re: **Geotechnical Review of Site Servicing Plans
Proposed Residential Development
5618 Hazeldean Road – Abbott's Run – Block 13 – Ottawa, Ontario**

to: Minto Communities Inc. – **Erin Harrington** – eharrington@minto.com

date: October 27, 2025

file: PG7640-MEMO.03

FIGURE 1 - RECOMMENDED LATERAL ZONE OF INFLUENCE PROTECTION AREAS

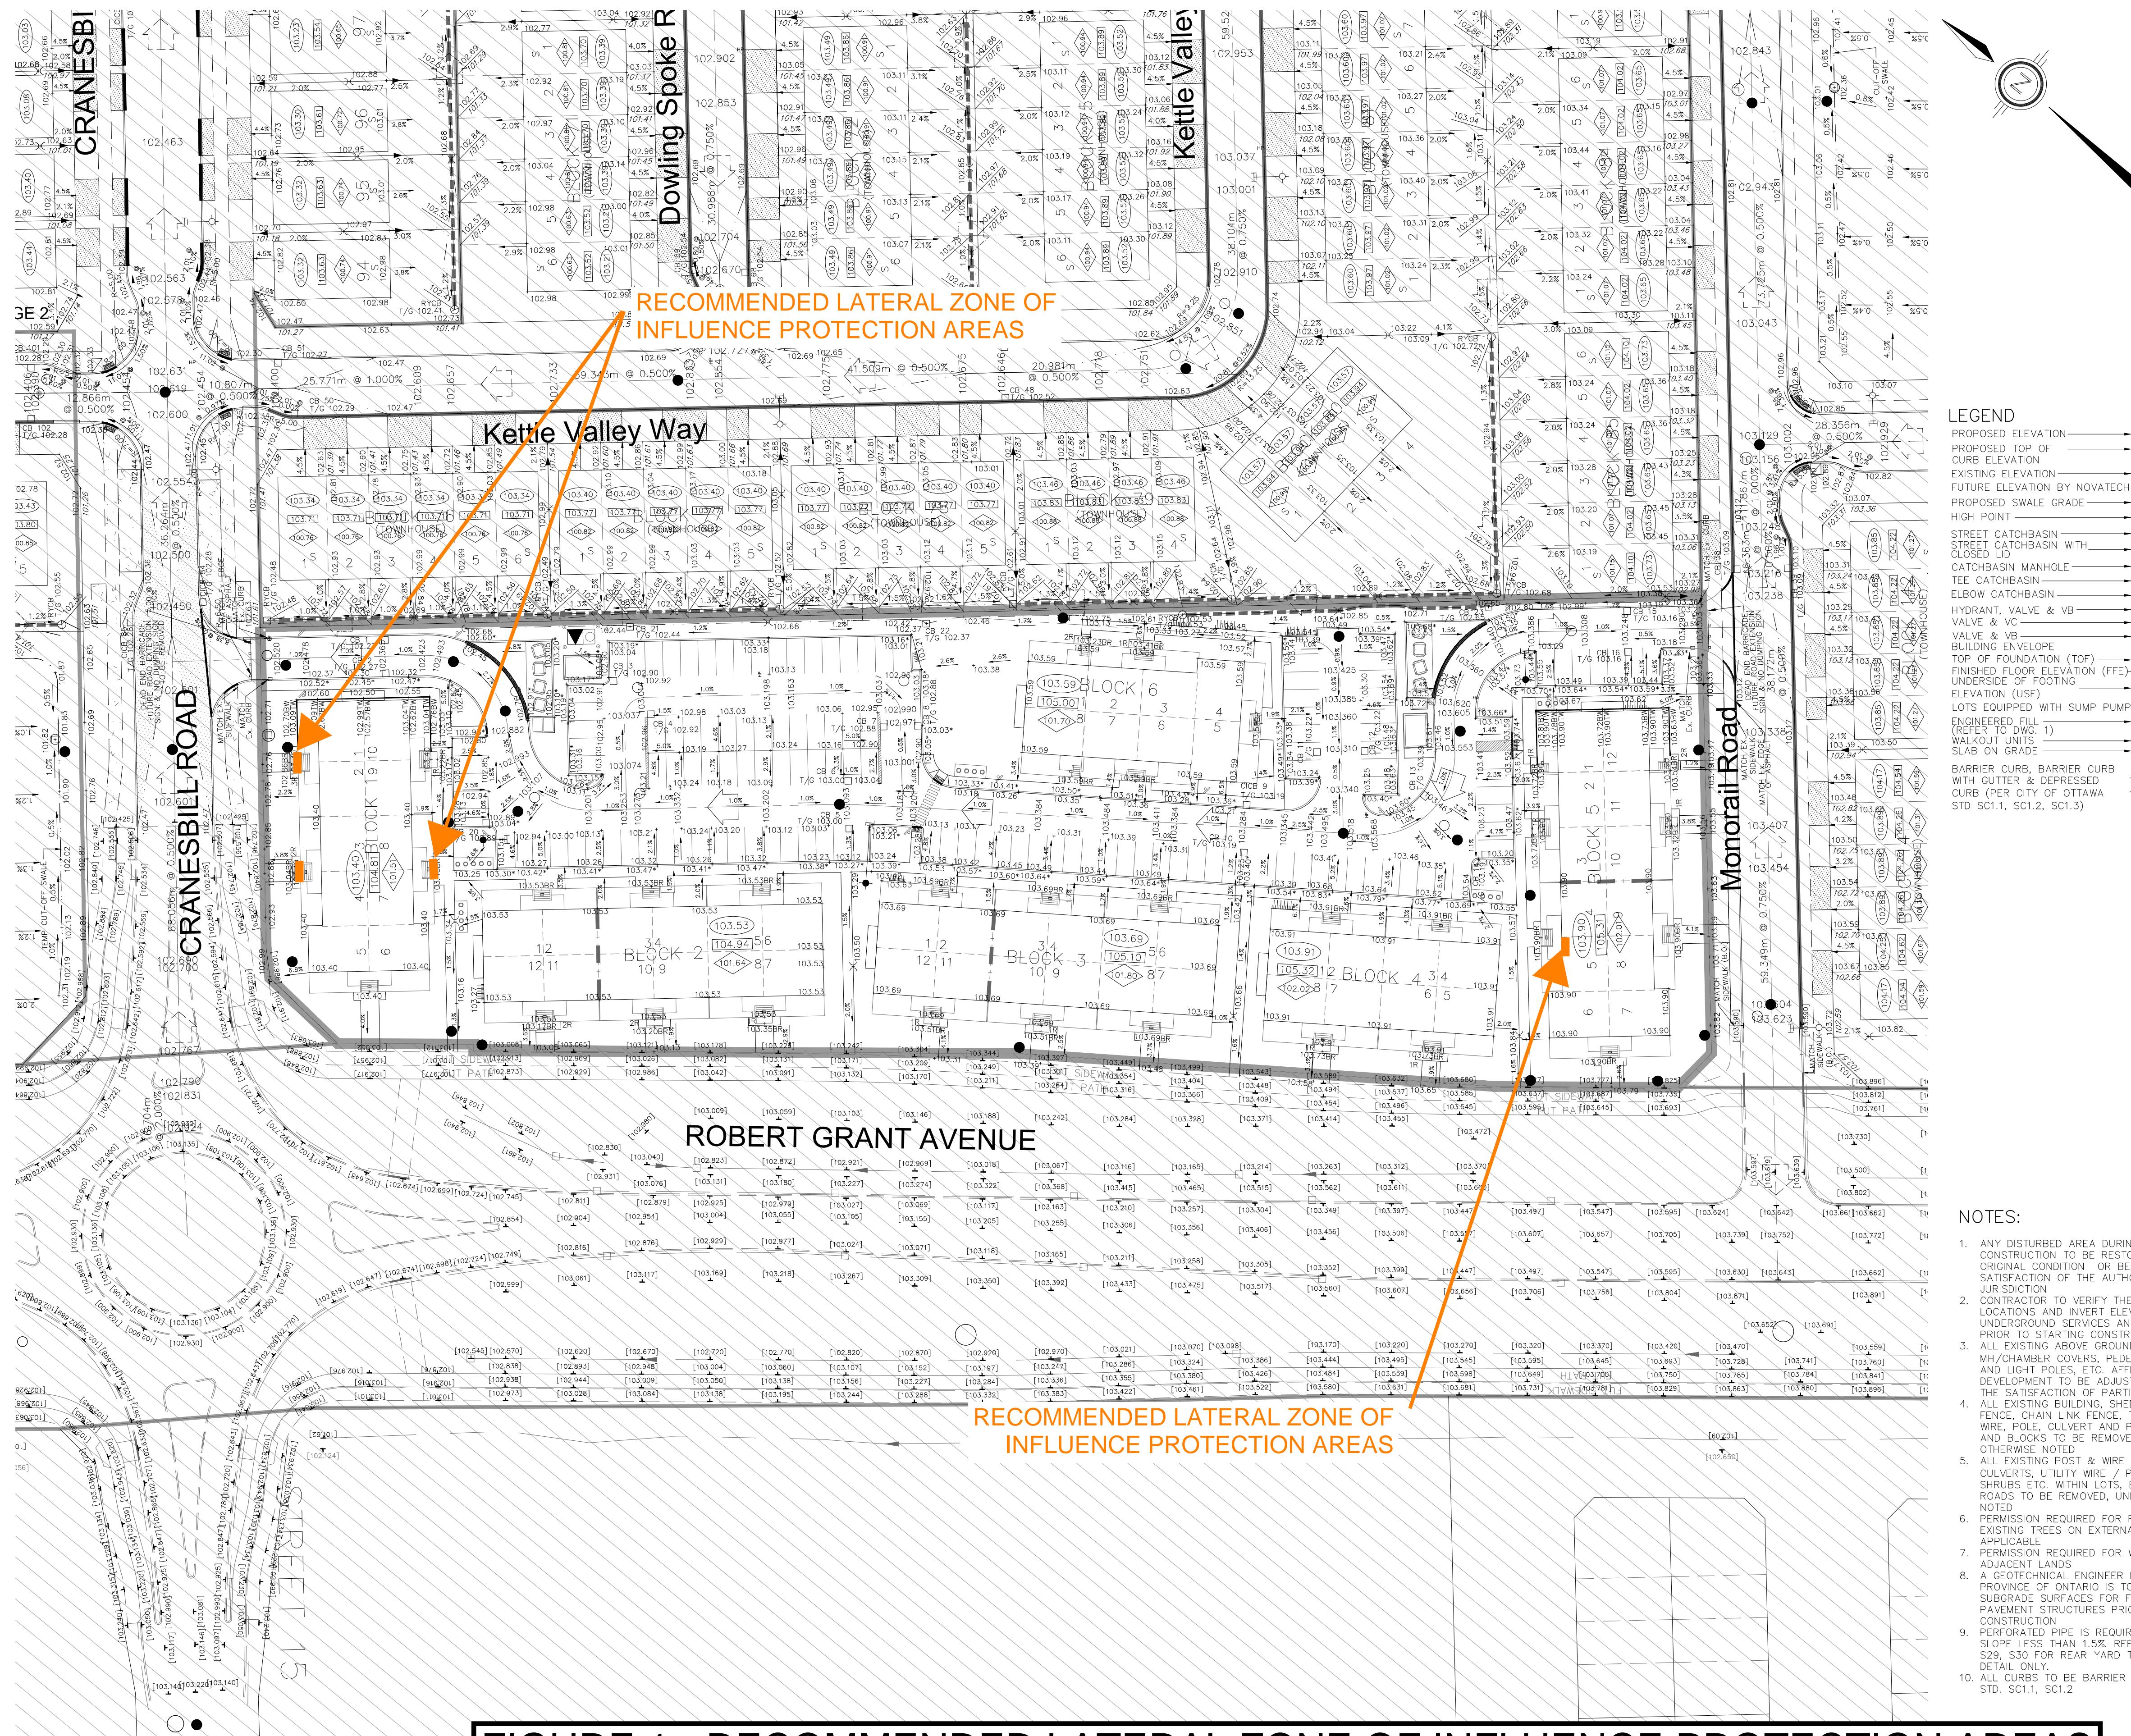
Paterson noted several areas in which underground services are proposed within the lateral zone of influence of the adjacent proposed buildings (i.e. within the plane extending 1 Horizontal:1 Vertical down and outwards from the edge of proposed footing). To ensure that the proposed services do not incur additional loading due to the adjacent proposed dwellings, and to permit future maintenance of the underground services without causing detrimental effects to the adjacent structures, Paterson has provided additional construction recommendations in subsequent sections of the present memorandum

It is recommended that the lateral zones of influence be lowered in the affected areas such that the influence plane (1H:1V) extending down and outwards from the edge of the proposed footings do not contain any underground services. This may be accomplished by extending the underside of footing (USF) for impacted strip footings to the elevations provided in Table 1 below. Alternatively, this may be accomplished by casting a near-vertical lean-concrete (minimum 15 MPa, 28-day strength) in-filled trench extending between the design underside of footing elevation to the recommended elevations provided below in Table 1 to a depth which would be unaffected by service trench works. The near vertical, zero-entry trench should extend horizontally a minimum 150 mm beyond the overlying footing faces.

The extents of the trench running below a strip footing and adjacent to a site service pipe should be terminated by extending the trench upwards and back up to the design underside of footing elevation at an incline of 1H:2V along the opposite oriented-running strip footings. Reference should be made to the attached Figure 1 – Recommended Lateral Zone of Influence Protection Areas for approximate locations in which the above-noted recommendations should be carried out.

Block / Lot Number	Current USF Elevation (m)	Revised USF/ Underside of Lean-Concrete Trench Elevation (m)	USF Concrete Trench Depth (m)
Block 1 – Unit 1 & 2 Staircase Footing	101.51*	100.31	1.20
Block 1 – Unit 3 & 4 Staircase Footing	101.51*	100.31	1.20
Block 1 – Unit 7 & 8 Staircase Footing	101.51*	100.61	0.90
Block 5 – Unit 4 & 5 Staircase Footing	102.01*	100.11	0.90

The zero entry, near-vertical trench sidewalls are intended to act as the formwork to cast the concrete. The bottom of the excavation should be reviewed by Paterson personnel prior to placing concrete. Once the trench excavation is approved by Paterson, lean concrete can be poured up to the design underside of footing elevation.
